P96-029 - G12 AUTO REPAIR SHOP

REQUEST: A. Special Permit Modification to expand an existing non-conforming 5,000± square foot auto repair shop by adding an additional 1,488± square feet of garage area on 0.44± developed acres in the General Commercial (Neighborhood Corridor) (C-2(NC) zone.

**NOTICE OF DECISION AND FINDINGS OF FACT FOR
G-12 AUTO REPAIR, LOCATED AT 2000 16th STREET,
SACRAMENTO, CALIFORNIA IN THE
GENERAL COMMERCIAL (NEIGHBORHOOD CORRIDOR) (C-2{NC}) ZONE. (P96-029)**

Exhibit 1-A Site Plan
Exhibit 1-B Elevation Plan

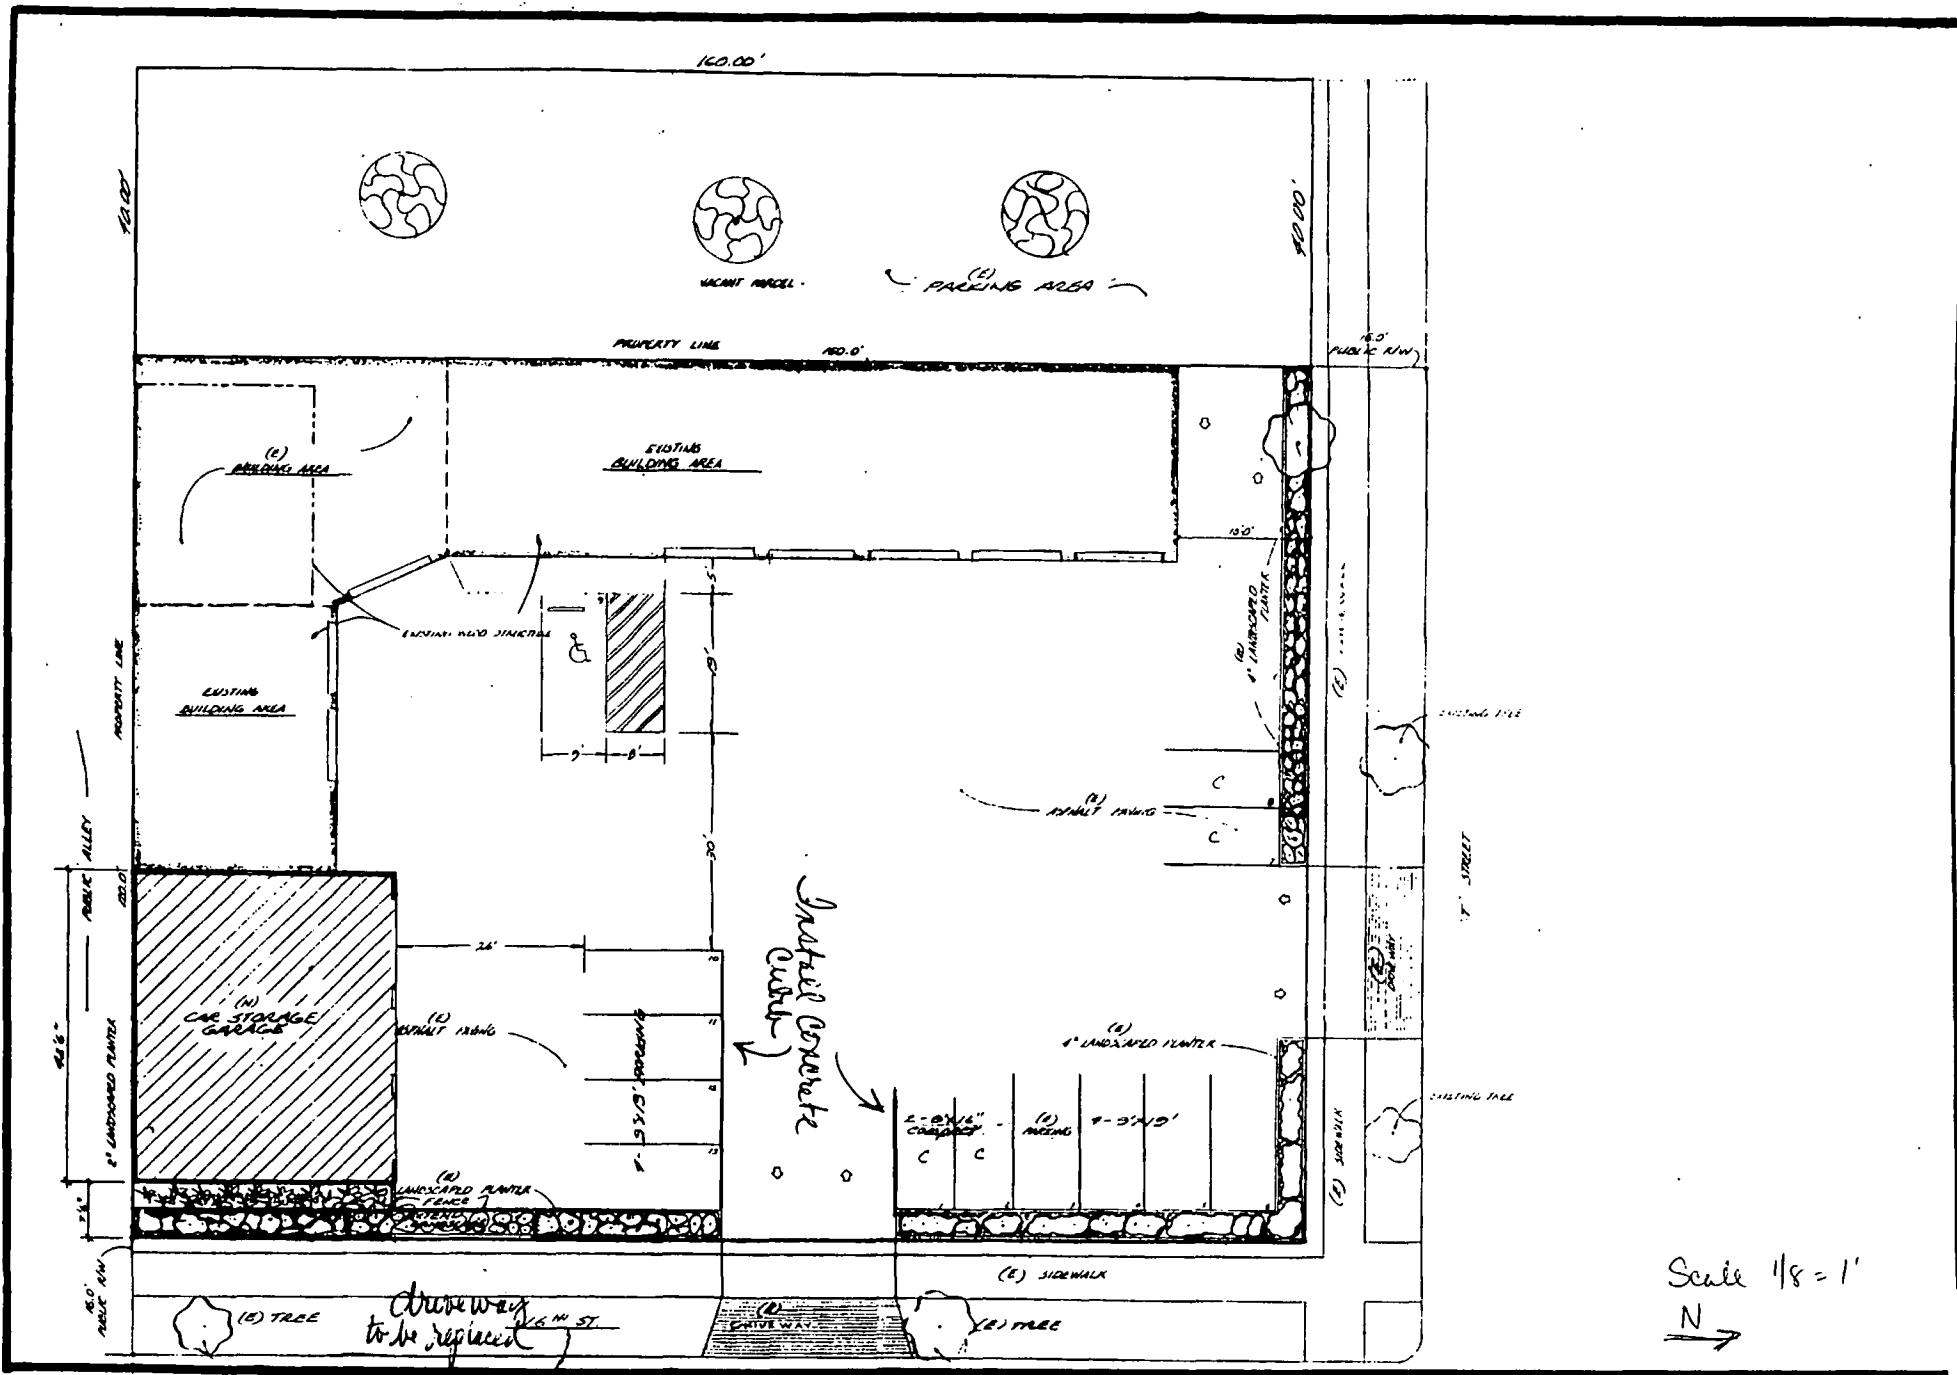
Access to the site is currently provided by three driveways, two located on 16th Street and one on T Street. The applicant is proposing to eliminate the southernmost driveway on 16th Street. With the removal of the southernmost driveway, staff recommends that sidewalk, curbs, gutters, landscaping strip and irrigation be installed to the satisfaction of the Public Works Department.

Adequate parking is provided on site. One parking space for every 500 gross square feet of building area is required for general commercial uses such as an auto repair shop. A building of 6,490± gross square feet requires 13 parking spaces. The site plan indicates 13 parking spaces will be provided on site. The handicapped parking space will be provided adjacent to the building, close to the office area. Four parking spaces are provided south of the driveway entrance on 16th Street. For these spaces, staff recommends a six inch continuous concrete curb be provided on the north side of these parking spaces. In providing a six inch curb on the north side of these spaces, drivers will be required to pull into the lot and access these spaces using the aisle provided between the proposed building

and parking spaces, thus eliminating stacking and maneuvering problems in the driveway entrance. In order to make the driveway entrance more symmetrical staff further recommends a six inch continuous concrete curb the length of the parking stall on the north side of the driveway.

The plans indicate that additional planter area and fencing will be installed where the driveway will be removed and in front of the proposed building. The proposed planter and fencing will be consistent with existing planter area and fencing already established along the perimeter of the site. Staff finds that the landscaping provided at this site is appropriate for the neighborhood since very little landscaping is provided on other sites. Properties in the area rely on the landscape planters in the public right-of-way to provide landscaping for the area.

The applicant is proposing to locate a 3' X 10' (30± s.f.) sign on the 16th Street (east) side of the new building. The plans do not indicate if other signs are existing on the site. The Sign Ordinance allows two attached signs for each occupancy. The signs shall not exceed a total aggregate area of three square feet of sign area for each front foot of building occupancy. The proposed sign is consistent with the Sign Ordinance. The applicant shall be required to obtain a sign permit prior to installation of the sign.

- B1. The southernmost driveway on 16th Street shall be eliminated. The driveway shall be replaced with curb, gutter, sidewalk, landscape planter with irrigation to the satisfaction of the City's Public Works, Transportation and Engineering Planning Division. The landscape planter shall be planted with lawn, shrubs or flowers and a tree.

- B3. The applicant shall submit a Statement of Recycling Information prior to issuance of occupancy permit.
- B4. The applicant shall construct a six inch continuous curb along the south side of the 16th Street driveway where the four parking spaces are located.

- B5. The applicant shall construct a six inch continuous curb along the north side to the 16th Street driveway for the length of the parking stall.
- B6. The project shall be reviewed and approved by the Design Review staff prior to issuance of building permit.

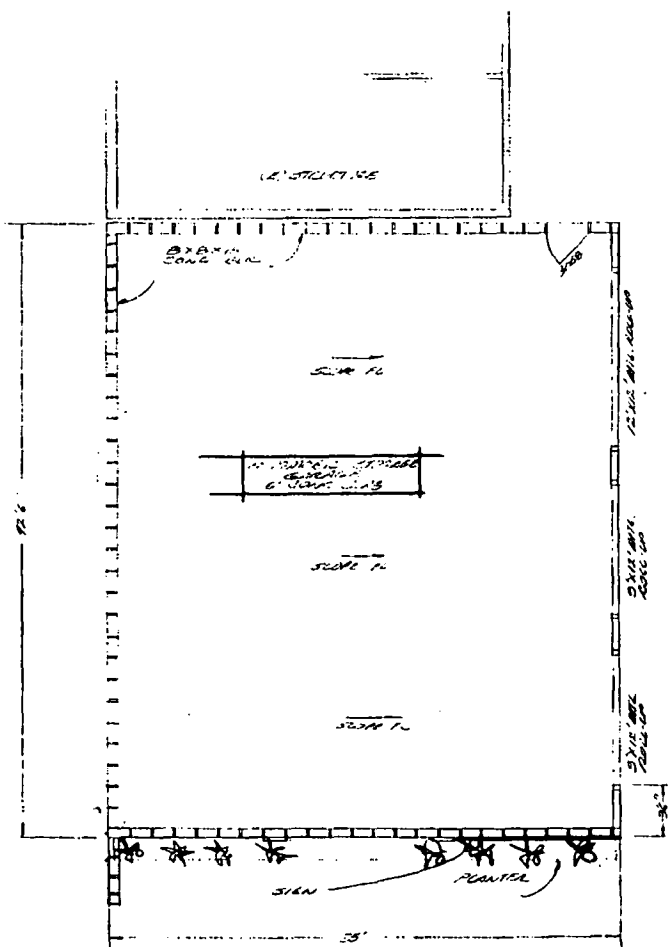
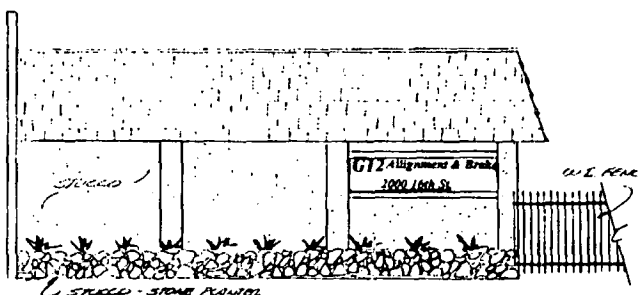
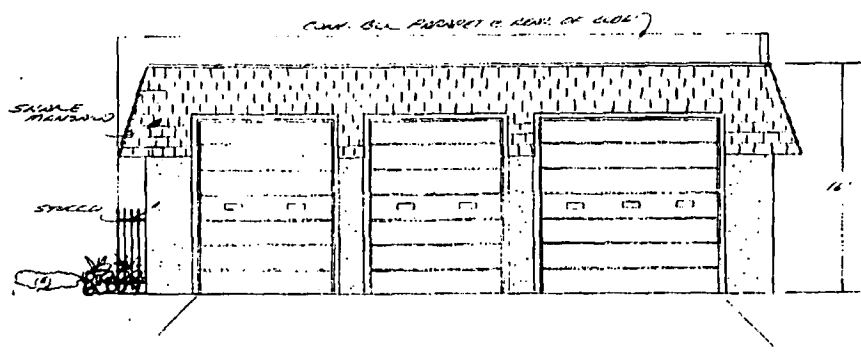
The proposed 42.5' X 35 foot single story building will be stucco with a shake mansard roof. The existing buildings on the site are constructed of T-1-11 redwood with a composition roof. Originally the applicant had proposed to utilize T-1-11 for the proposed building. However, Design Review staff has recommended that the applicant use stucco. Since the site is located within the Central City Design Review area the proposed project is subject to review an
